RE: Indian Point Unit No. 3
Docket No. 50-286
REGULATORY DOCKET FILE COPY

ENCLOSURE 1

REQUEST FOR ADDITIONAL INFORMATION

STRUCTURAL INTEGRITY TEST
INDIAN POINT UNIT NO. 3

FIG. 2.1

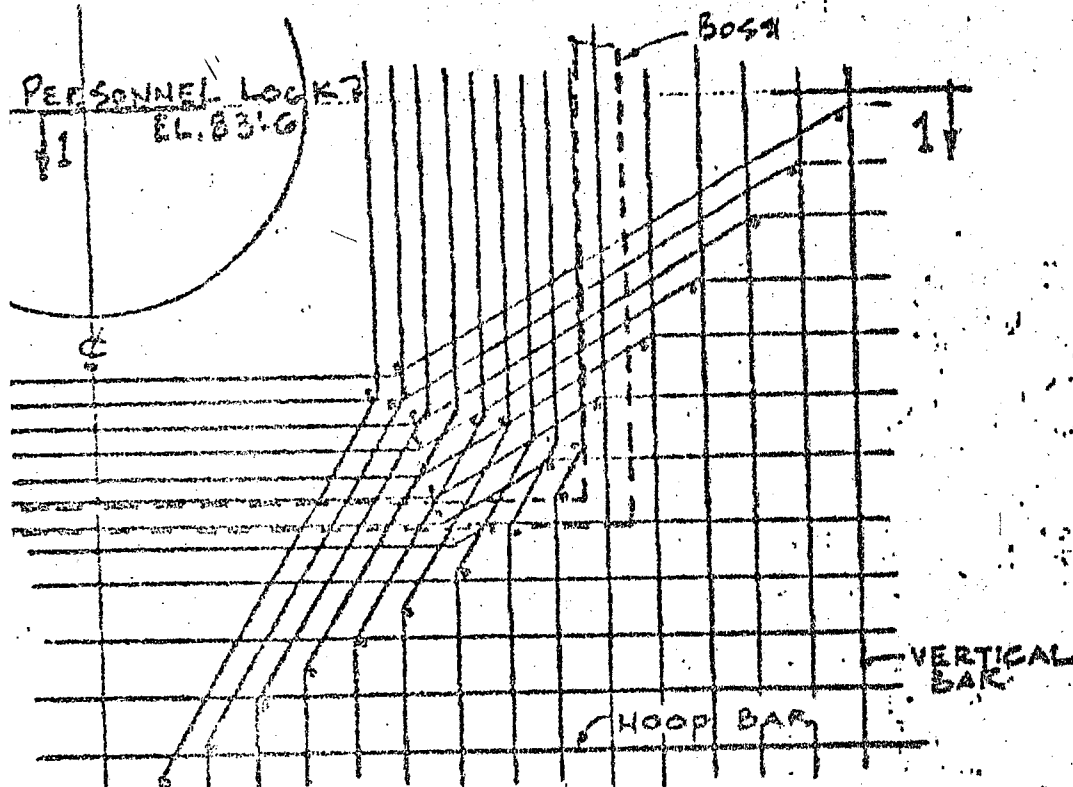
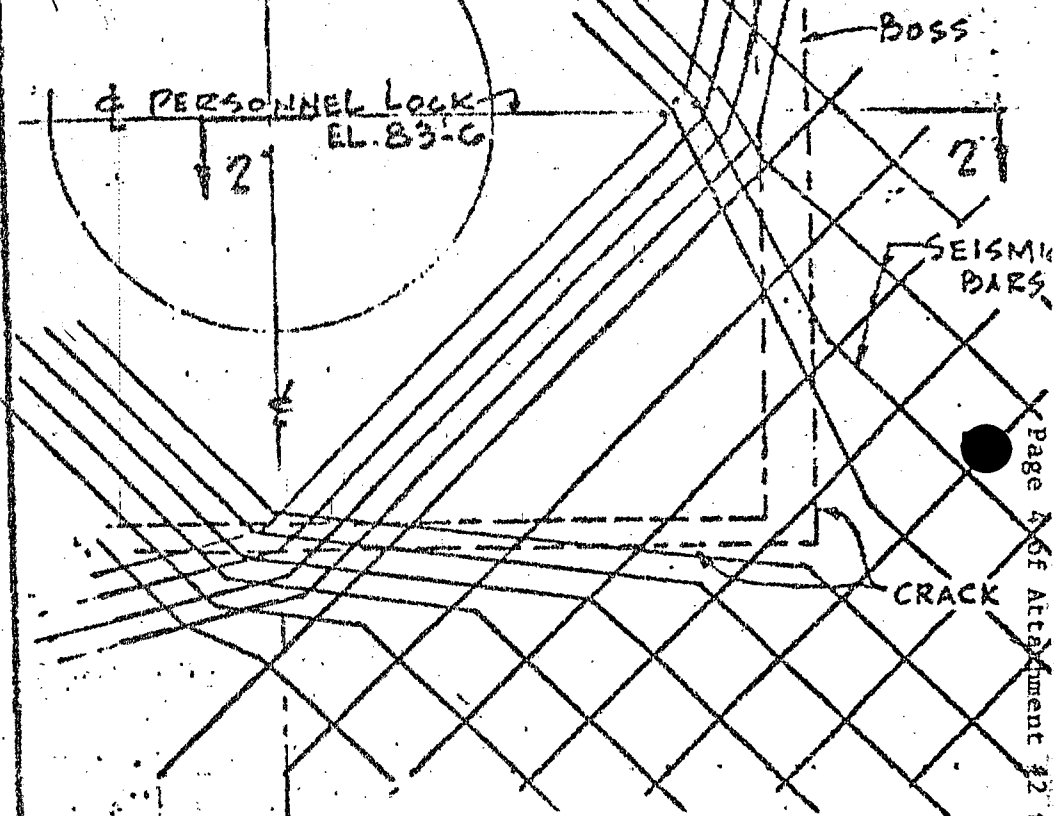
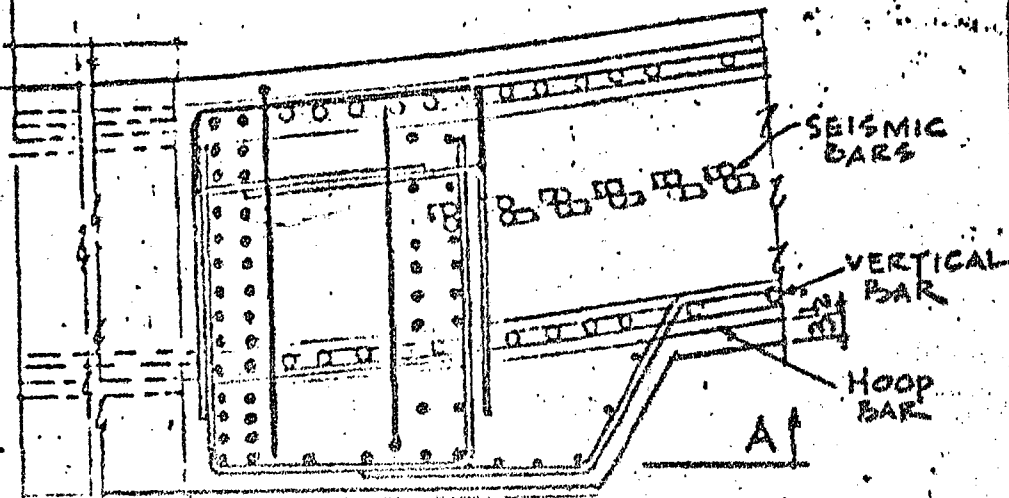
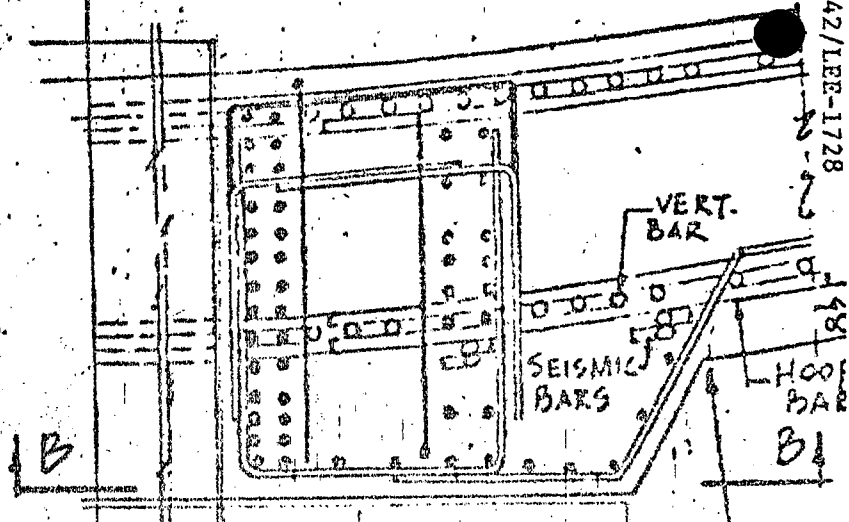
- c. Your explanation of the magnitude of the subject crack requires further clarification. Discuss the difference in location of rebars in containment for Units No. 2 and No. 3 and its effect on the crack width in a comparative form. Provide a more rational explanation of the differences than that given under item e) of Section IX and demonstrate that the excessive cracking will not impair the structural integrity of the containment.

The difference in rebar placement between Unit #2 and Unit #3 can be seen in the attached Fig. 2.1. For Unit #3 the outermost rebar is the seismic rebar. As shown in Figure 8 under Tab IX a large void is created when the seismic rebar bends around the opening. Figure 8 is the design drawing. It can be seen that a slight shift in seismic rebar location could cause a large void in seismic rebar at the lower left corner where the largest cracks occurred (see Figure 2.1). The first layer of rebar crossing the crack is thus the diagonal rebar in the orthogonal direction to the layer with the void in the crack area as shown in Figure 2.1 for Unit #3. Due to the 30" spacing of the rebar only one bar can potentially cross the crack area. In addition the horizontal rebars, which are most effective for vertical crack control are 8½" from the surface for Unit #3 since they are pushed further into the section by outside seismic rebar. For Unit #2, where the outside layer of rebar is the horizontal rebar which crosses the potential crack, the concrete cover is 3½". The differences in concrete cover between

Units #2 and #3 in Figure 2.1 comparatively illustrate the differences in rebar placement between Units #2 and #3 and provide an explanation why greater concrete cracking could be expected for Unit #3.

As stated in Item c) of Section IX the primary loads are carried by the rebar in this area; therefore the existence of concrete cracking is not a problem by itself. The concrete cracking is monitored during the test as an indicator of where rebar stresses may be high. Based on the many reasons why cracking is expected in this area as detailed in Section IX and the observation in Item f) of Section IX that the crack closed properly as pressure was reduced, the concrete cracking in this case does not indicate the presence of unacceptable rebar stresses.
